DESIGN/PROCESS CHANGE NOTIFICATION -- FINAL

Change Type Description: Alternate Assembly/Test Location/Qualification

Description of Change (From): MOSFET products identified in the Affected FSID list assembled at Fairchild Semiconductor in Suzhou, China (FSSZ).

Description of Change (To): GEM Electronics Shanghai, China is now qualified to produce the MOSFET devices identified in the Affected FSID section on this PCN. GEM Electronics has been a qualified assembly and test manufacturer for Fairchild Semiconductor since 2001.

D-pak Package visual comparison as below

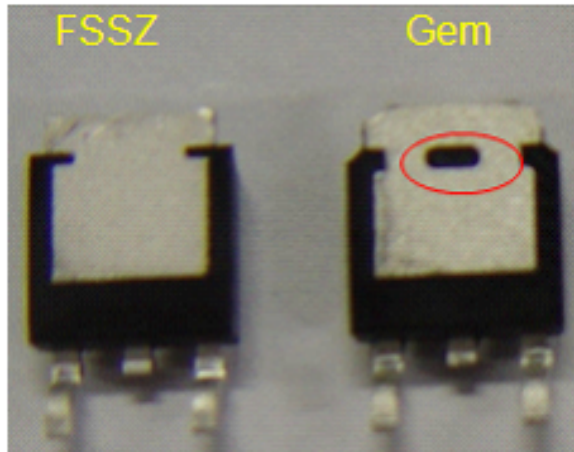
Note: there is a slot hole on GEM D-PAK heat sink surface compared with Fairchild Suzhou (FSSZ) product. There is no impact to the application
